**From:** "Lindgren, Donald A." <lindg1da@westinghouse.com>  
**To:** "jnw@nrc.gov" <jnw@nrc.gov>, 'Lauren Quinones' <LNQ@nrc.gov>  
**Date:** Wed, Nov 2, 2005 7:32 PM  
**Subject:** AP1000 DCD Flow Sensor Changes and Response

**PROPOSED REVISION 15**  
**AP1000 DESIGN CONTROL DOCUMENT**

**Reactor Coolant System Flow Sensor**

15.3.1-2

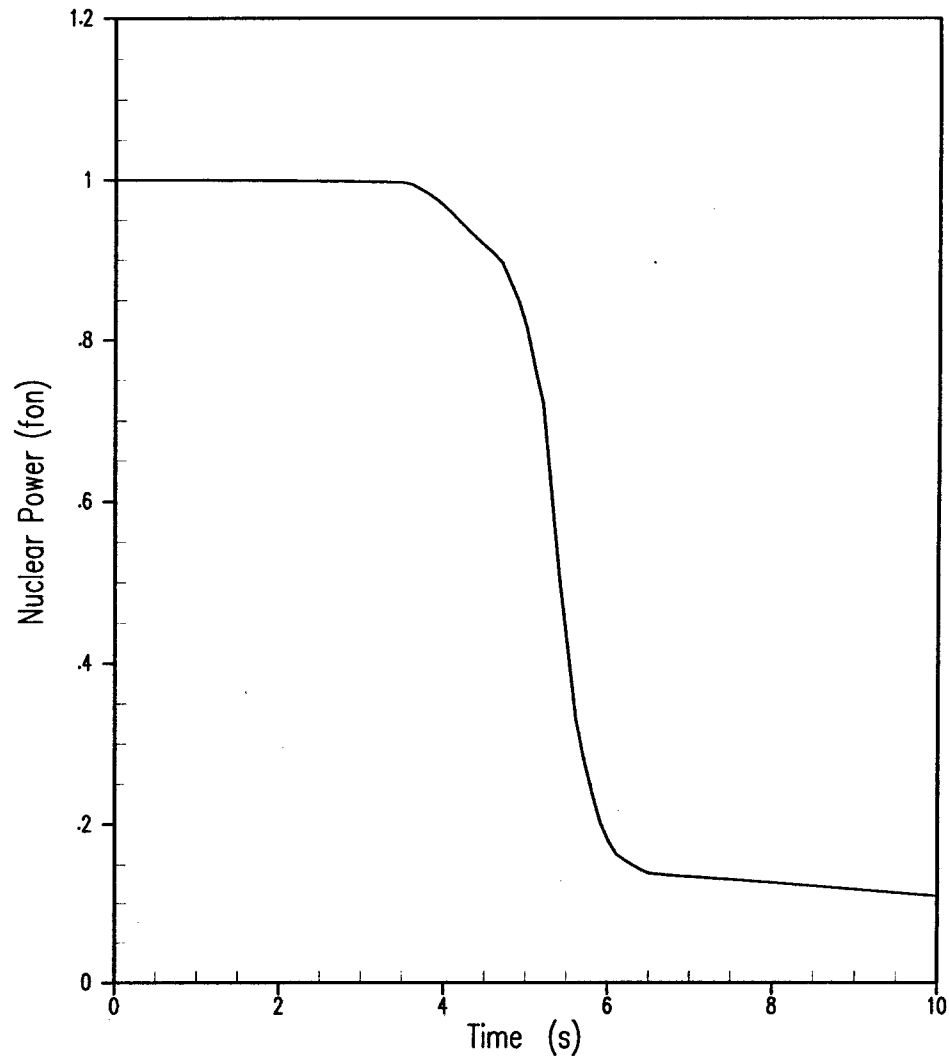
References in Tier 2 text and tables to the cold leg flow signals are also changed to hot leg signals to be consistent with Tie 1 changes. Chapter 15 Figures related to analysis of partial loss of forced reactor coolant flow and the locked rotor event are also revised. The RCS loop layout, RCS P&ID, and the protection system functional diagram that show the flow instruments are revised.

There is a small impact on the analysis results of partial loss of forced reactor coolant flow (Subsection 15.3.1) since reactor trip will be on low hot leg flow instead of low cold leg flow. Since AP1000 hot leg flow is the total of two cold legs, the reactor trip will be somewhat slower (less sensitive to trip of a cold leg pump). The acceptance criteria for the partial loss of flow event continue to be met with margin. The more limiting complete loss of forced reactor coolant flow event (Subsection 15.3.2) is not impacted. There is a very small impact on the locked rotor event (Subsection 15.3.3), but the acceptance criteria continue to be met with a wide margin. The time for the hot leg to drop to 87% flow is approximately 1.0 seconds slower for a trip of two reactor coolant pumps, and approximately 0.067 seconds slower for a locked rotor.

**Tier 2 Figures 15.3.1-2 through 15.3.1-6** Replace Tier 2 Figures 15.3.1-2 through 15.3.1-6 with the following figures:

Figure 15.3.3-3

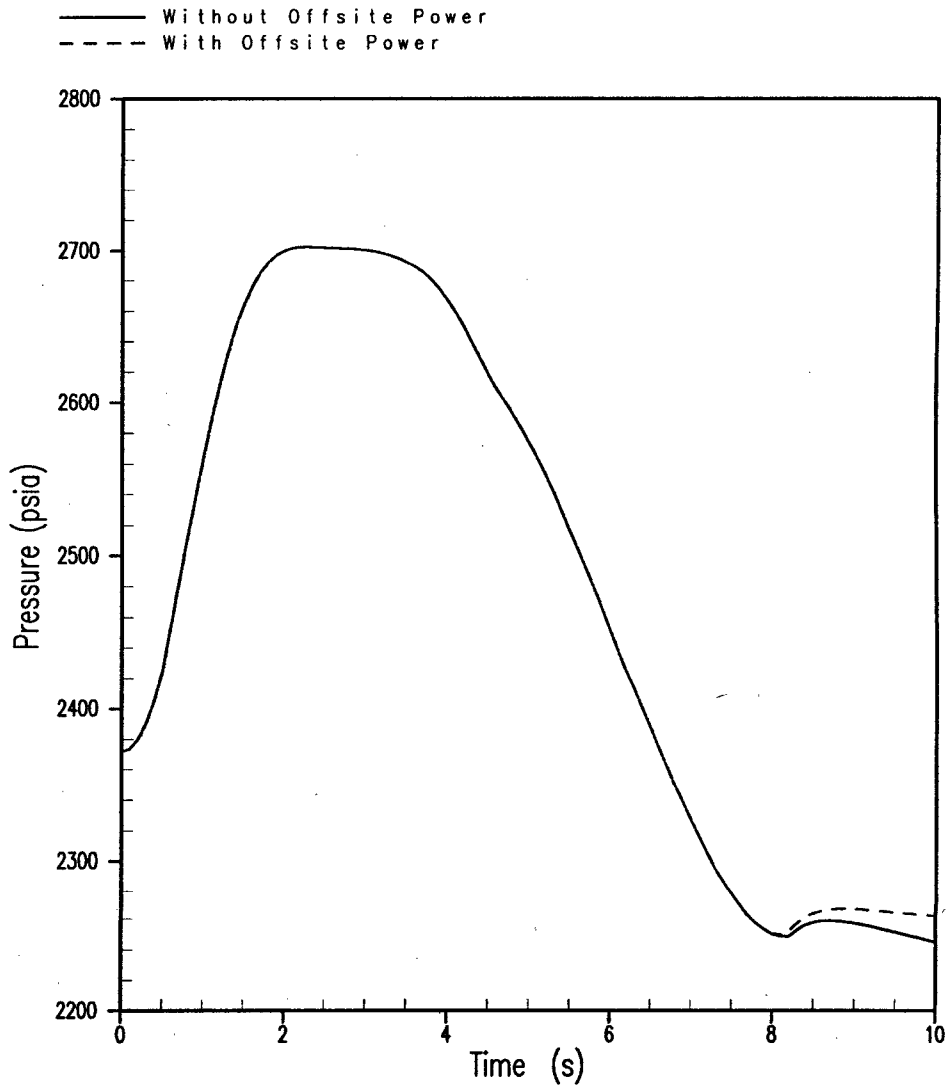
**Tier 2 Figures 15.3.3-3 through 15.3.3-7** Replace Tier 2 Figures 15.3.3-3 through 15.3.3-7 with the following figures:
